STAFF REPORT: 04/09/2025 MEETING
APPLICATION NUMBER: HDC2025-00062
ADDRESS: 15150 WARWICK

HISTORIC DISTRICT: ROSEDALE PARK
APPLICANT / PROPERTY OWNER: ERIC DANIEL
DATE OF PROVISIONALLY COMPLETE APPLICATION: 03/16/2025
DATE OF STAFF SITE VISIT: 03/29/2025

SCOPE: REPLACE WOOD WINDOWS WITH VINYL WINDOWS

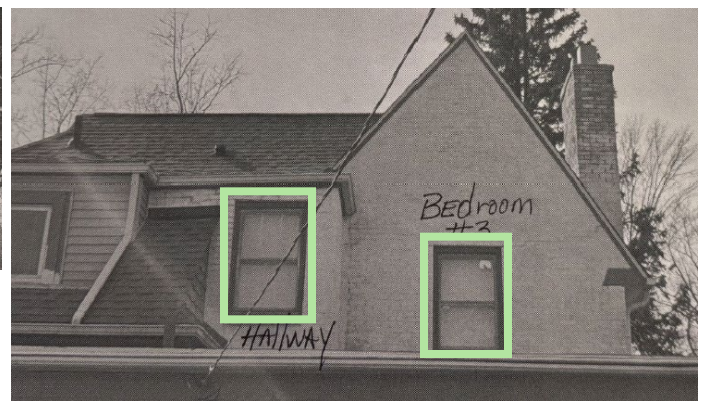
- Remove 8 historic wood windows and replace with Simonton 6100 vinyl windows, including metal wrap to cover the brick mould where applicable.
 - (2) Front of house, second floor, West elevation
 - (1) six-over-one
 - (1) three-over-one
 - (1) Side of house, first floor, South elevation
 - (1) pair of casements
 - (1) Side of house, second floor, South elevation
 - (1) three-over-one
 - (2) Side of house, second floor, North elevation
 - (2) three-over-one
 - (2) Back of house, second floor, East elevation
 - (1) three-over-one
 - (1) one-over-one
